USNRC APPLICATION
SUA-1341 License Amendment
Ludeman Project
Converse County, WY

June 2013

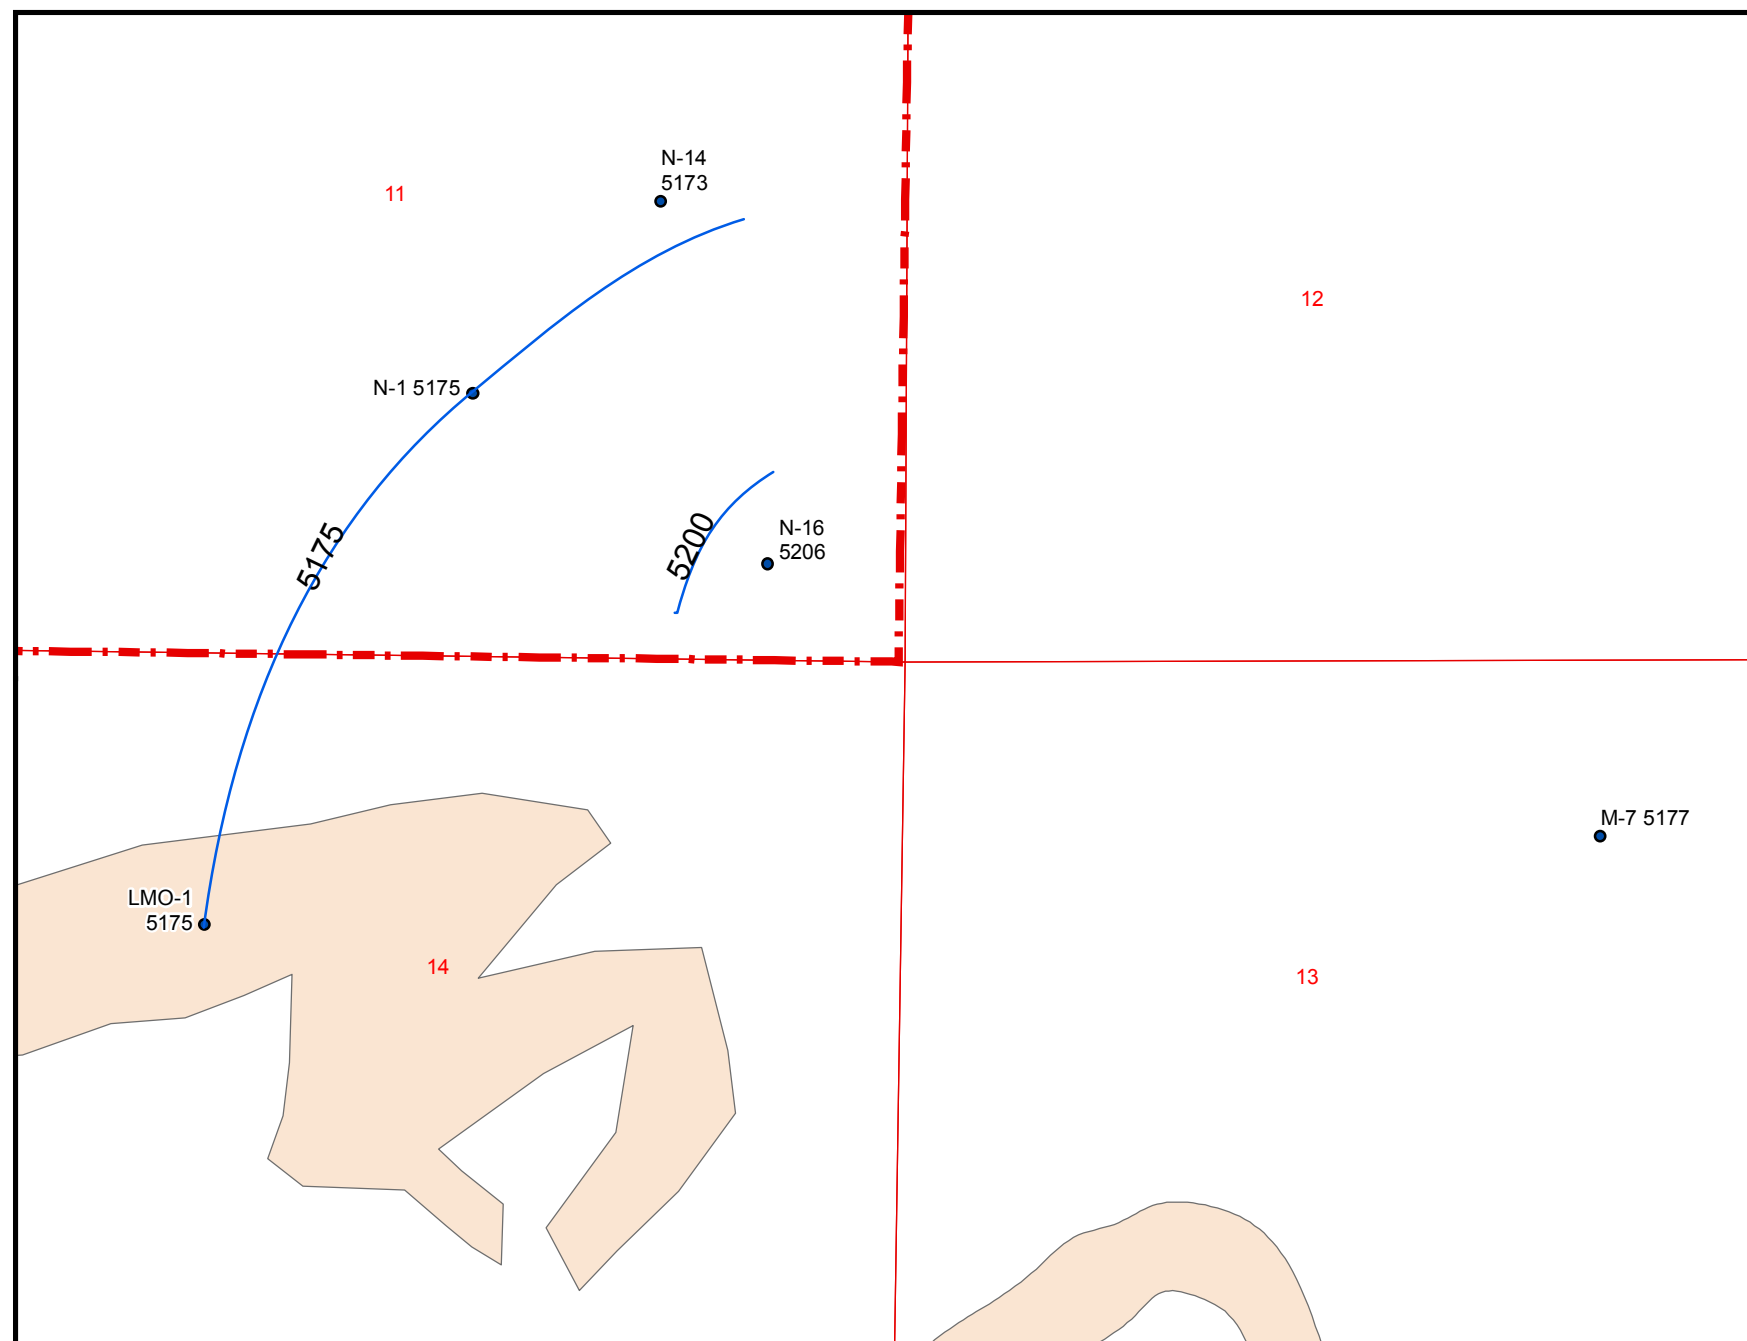
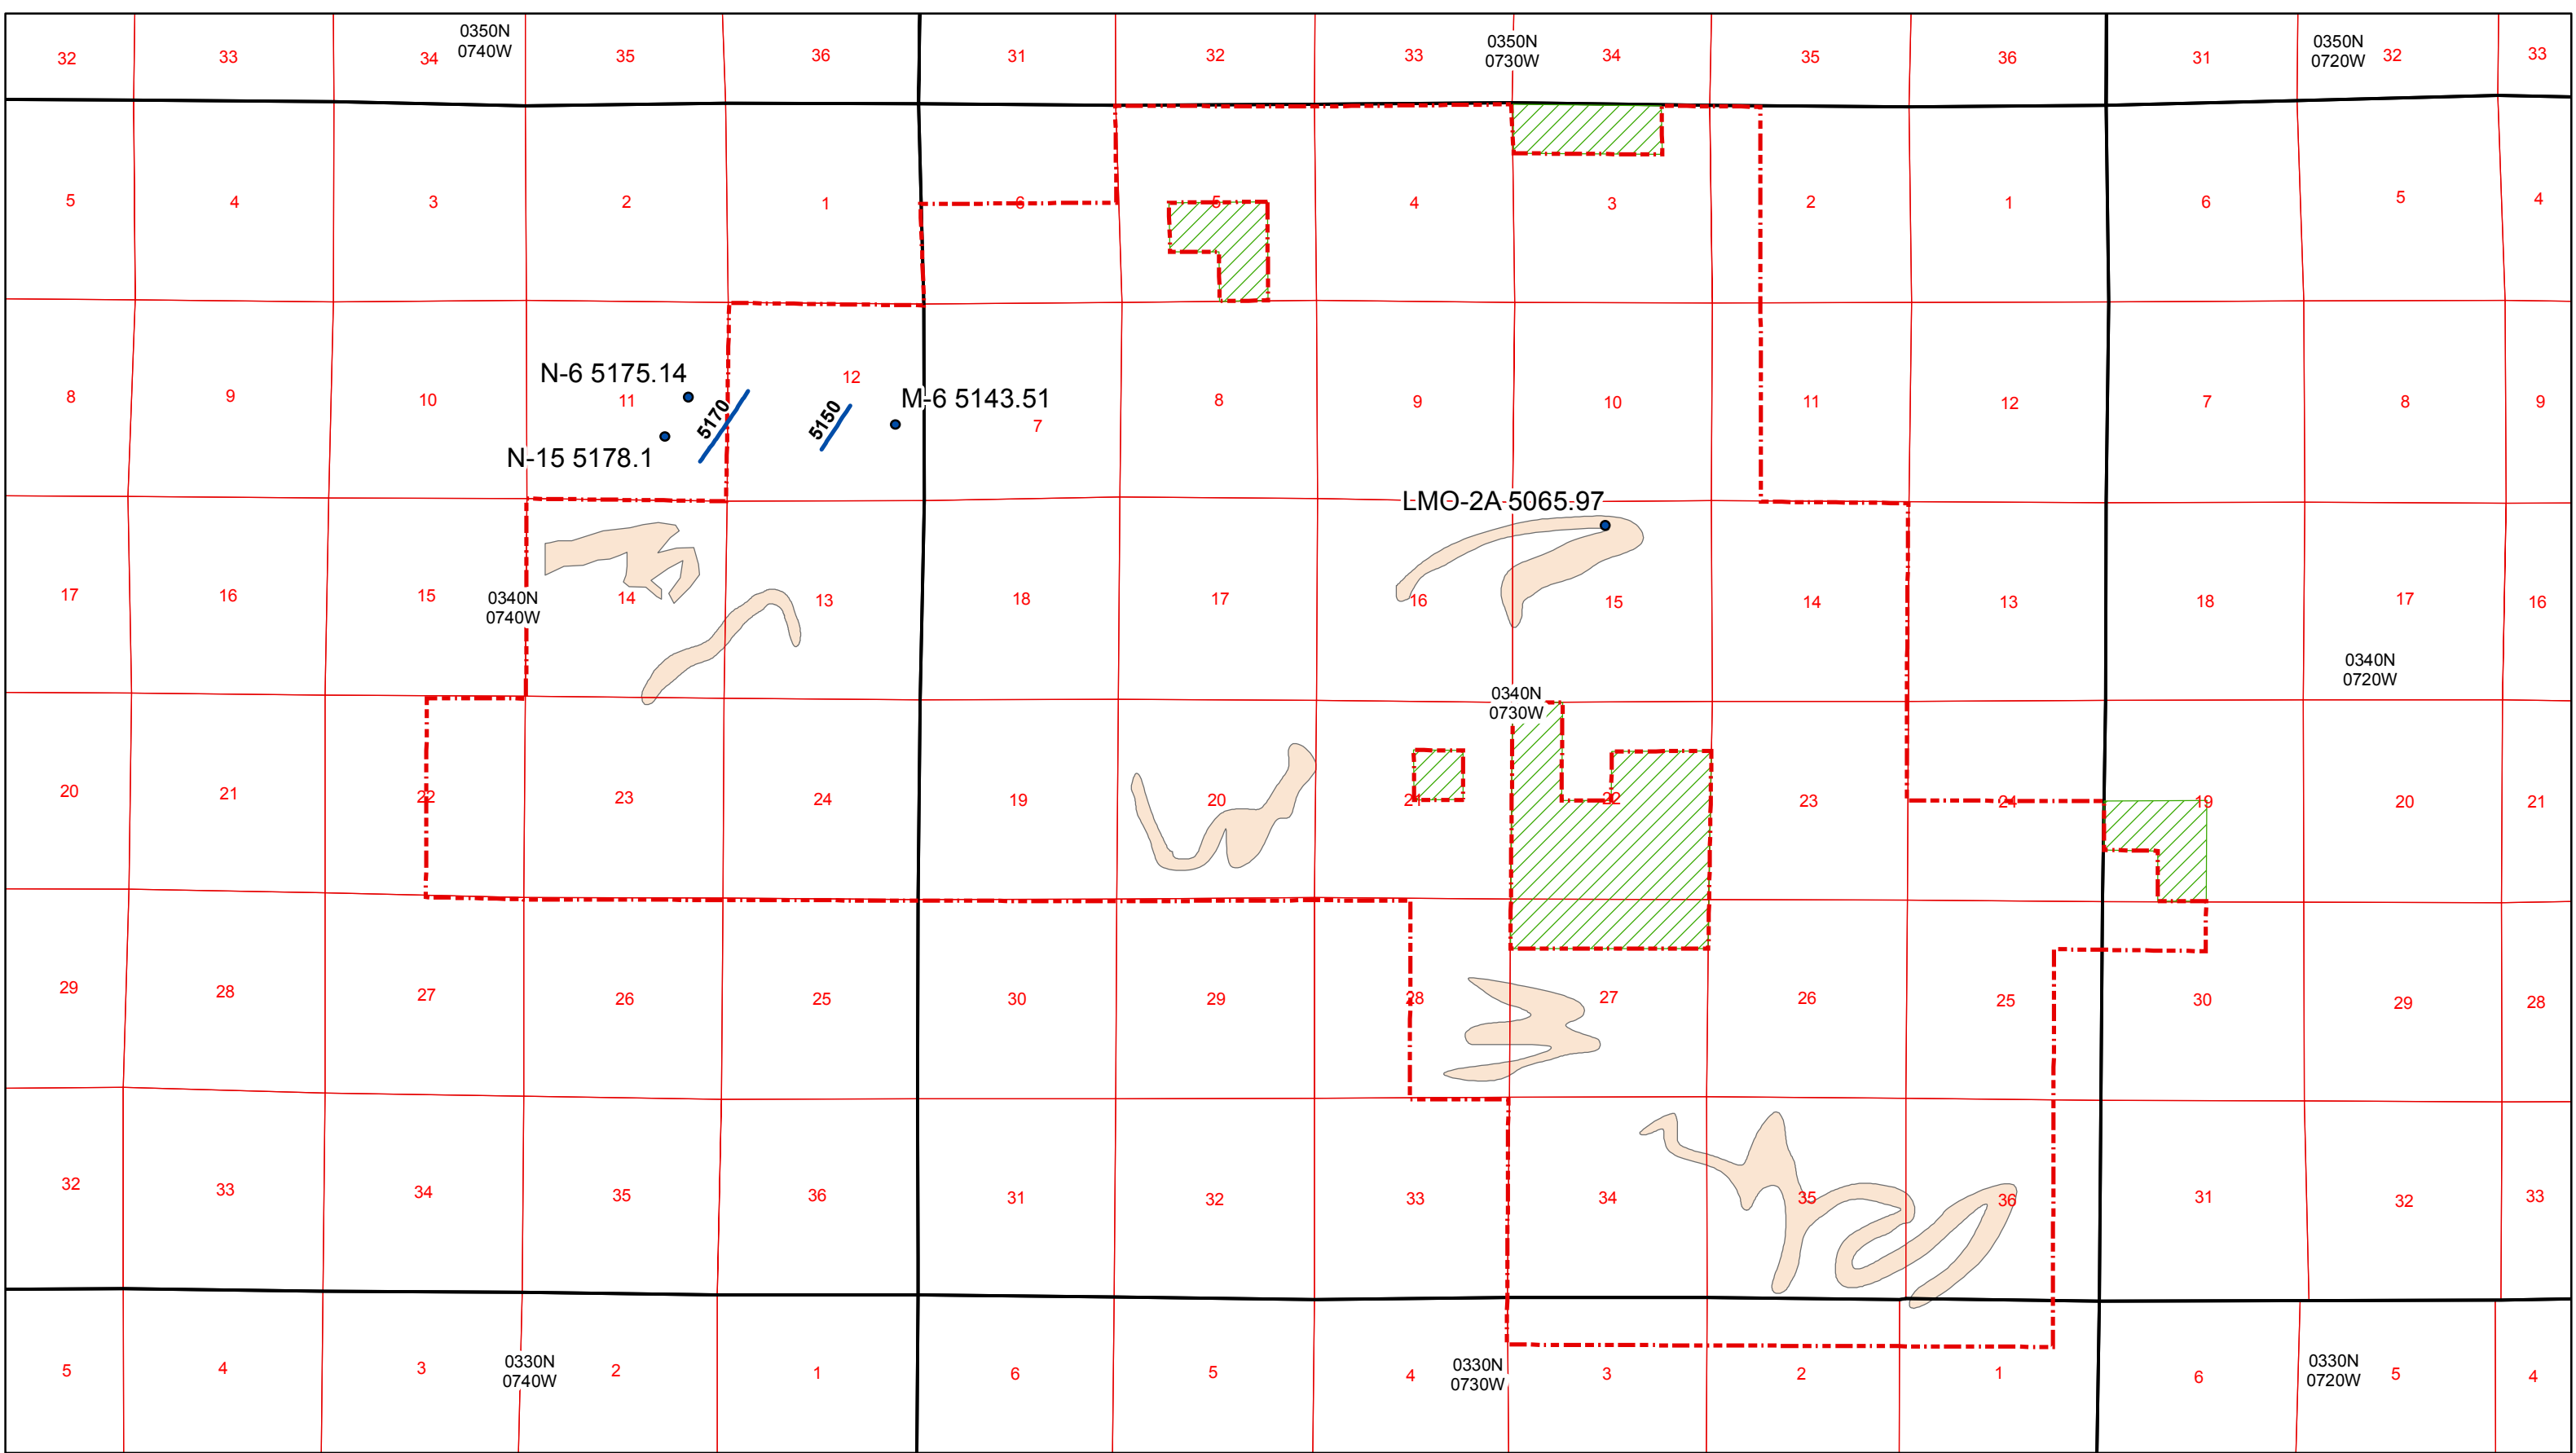
Staff evaluated the Addendum 2.7-C table “Summary of Monitoring Well Completions” and found the majority of the well top of casing (TOC) elevations in the tables were in conflict with well log ground surface elevations of the same wells provided in the cross sections in Figures 2.6-3 through 2.6-13. The table below presents the monitoring well top of casing elevations provided Addendum 2.7-C vs. the elevations provided on the cross sections. As can be seen in the table, there are often very large differences in the elevations. These differences call into question the aquifer water levels in mean sea level which were calculated based on the top of casing elevation. These water elevations are the basis for the potentiometric surfaces created for all the aquifers in the proposed license area. In addition, the selection of aquifer sand location is questionable if the well TOC elevation is inaccurate. Because of these errors, staff was unable to evaluate the potentiometric surfaces, ground water flow direction and magnitude for the Leuenberger, North Platte or Peterson Satellites. Staff is also unsure if Uranium One has made the appropriate identification for the location of the underlying sands and aquitards based on the elevation errors. Staff cannot evaluate or provide reasonable assurance for the safety of operations at any of the proposed satellites without correction of the elevations of these monitoring wells and all figures and calculations (e.g. sand top and thickness) which were based on them.

Uranium One should correct all monitoring well elevations noted to be in error on the table and correct all discussions, tables, maps, cross sections and isopachs which used the incorrect elevation information from these monitoring wells. In addition, Uranium One should ensure that all well surface elevations presented in the application are accurate and all calculations based on them are also accurate. Staff is especially concerned about the correction of the elevation of the overlying aquifer sand, ore zone aquifer sand, underlying aquifer sand and associated aquitards at each satellite.

Additionally, staff is very concerned about the potentiometric surfaces and vertical gradients between aquifers which were calculated based on these elevations. Staff notes that anomalous potentiometric surface mounds were associated with some of these elevation errors. Therefore, once corrections are made to the elevations, provide the corrected potentiometric surfaces and estimate the ground water flow magnitude and direction for all overlying aquifers, ore zone aquifers and underlying aquifers for the Leuenberger, North Platte, and Peterson Satellites. Uranium One should use available water levels from wells located within 2 km of the each satellite's proposed wellfields for these updated surfaces, not just the limited monitoring wells available to provide better estimates of ground water flow direction and magnitude.

Uranium One has updated the well elevations presented in Addendum 2.7-C Summary of Well Completions with survey data and subsequently the potentiometric maps. For the wells that did not have survey data available, NED elevations have been utilized. The review of the NED elevations versus the survey elevations showed that the NED data were quite close. Thus, in cases when new survey data were not available, the NED data should provide a good approximation of elevation. The cross sections and isopachs will not require updates as they utilized the survey data to develop the figures.

The updated potentiometric maps are shown below.
